## Statement to the transboundary Environmental Impact Assessment NPP Wylfa Newydd/UK

Horizon Nuclear Power is proposing to construct and operate a new nuclear power plant (NPP) at the Wylfa Newydd site in Wales at the coast on the Island of Anglesey. The new NPP shall comprise two UK Advanced Boiling Water Reactors (ABWR). The site already hosts two Magnox NPPs that were shut-down in 2012 and 2015.

**Wylfa-1**  
 Deposition from a 61.51 PBq release of Cs-137  
 Simulation start 19950825 14 Actual time 19950909 14

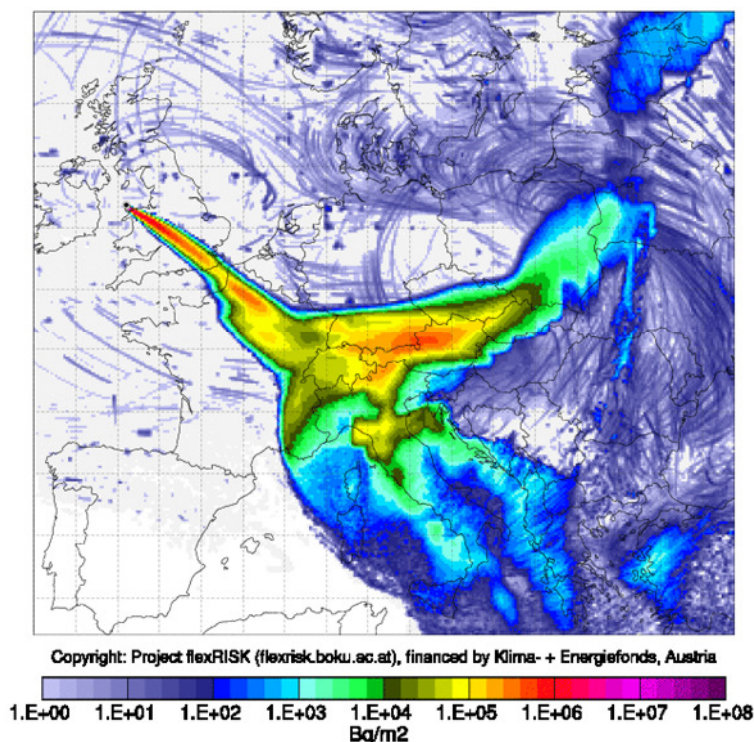
Austrian territory could be contaminated with several 100 kBq Cs-137/m<sup>2</sup> (between the orange and the light red scale). This is more than the contamination after Chernobyl, when 186 kBq Cs-137/m<sup>2</sup> was the Austrian maximum, the average<sup>15</sup> was 21 kBq/m<sup>2</sup>.

In Austria, agricultural countermeasures<sup>16</sup> have to start at an expected contamination with Cs-137 of 0.65 kBq/m<sup>2</sup>, a contamination which could be exceeded in the whole Austrian territory in case of such a severe accident.

**In case of a severe accident in Wylfa with a containment failure, whole of Europe could be contaminated severely.**

**Request: Any new NPP in UK needs to prove that a severe accident with a containment failure is not possible!**
